No. EL/3.2.19/3-Phase

Addendum-1

Sub: Addendum-1 to Modification Sheet no. RDSO/2012/EL/MS/0412 Rev '0' dated 22.08.2012

Fig.1 MS Pipes for CP1 & CP2

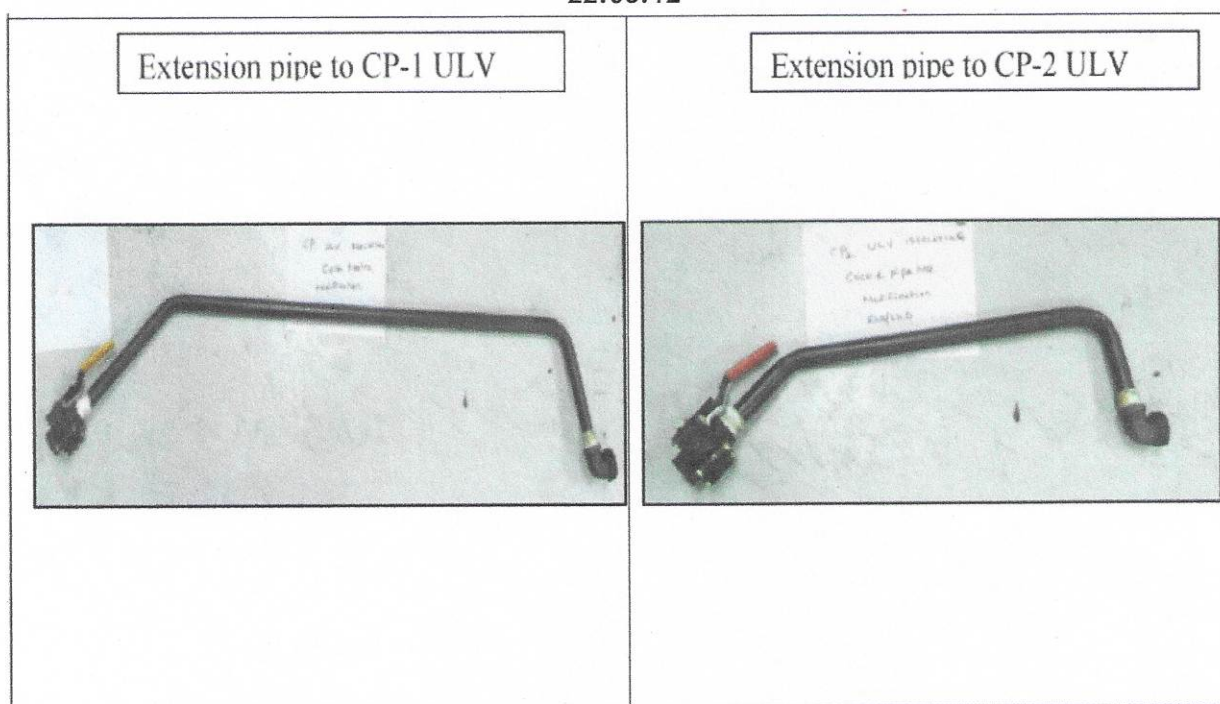
- Connect the nipple (1 inch x ½ inch x 2 inch length) from unloader exhaust port.
- Prepare the pipe (bend & thread both end), connect one end with ½ inch isolating cock and other end with elbow union (1/2 inch x ½ inch) as shown in fig.1 & 2
- Now connect the pipe with nipple through elbow union.
- Provide suitable clamps to hold properly the arrangement.

Fig.3 Photographs for CP1 & CP2 ULV isolating cock arrangement

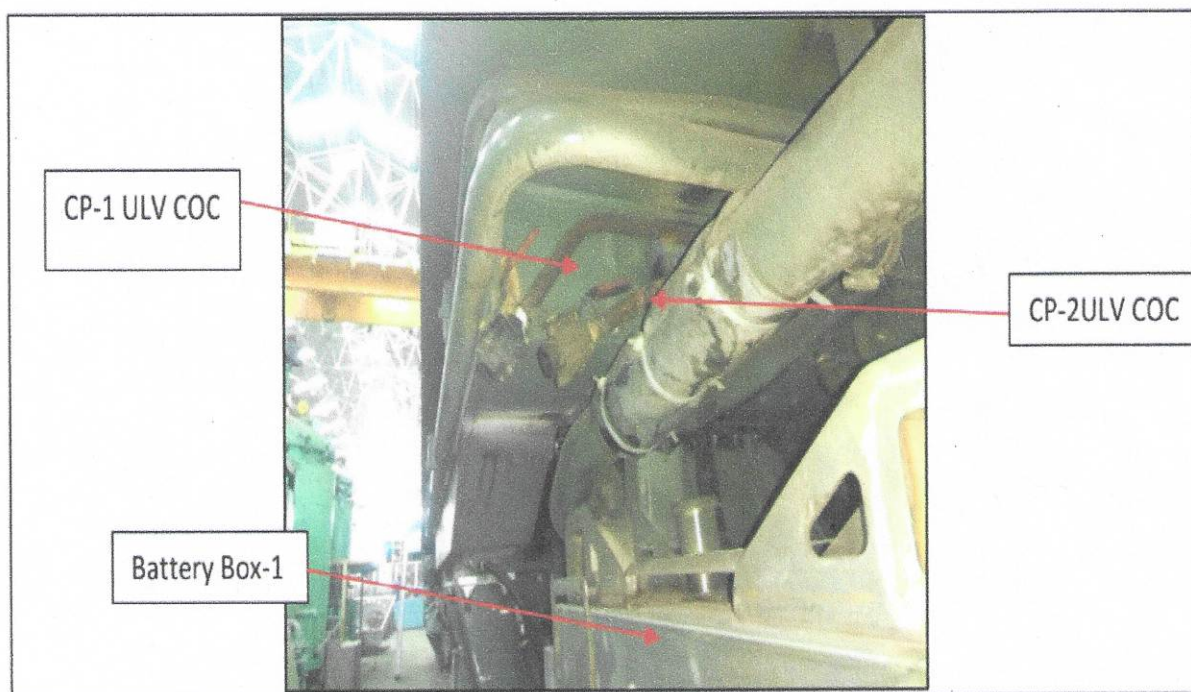
Southern Railway reported in 39th MSG that it is very difficult to operate the CP1 ULV isolating cock in case of any failure of ULV in mid-section due to inaccessible location.

Solution: To overcome the above issue the CP1 and CP2 unloader valve isolating cocks may be relocated at the approachable area along the side body of the locomotive above the battery box no. 1 by providing extension pipes as shown in fig.3.
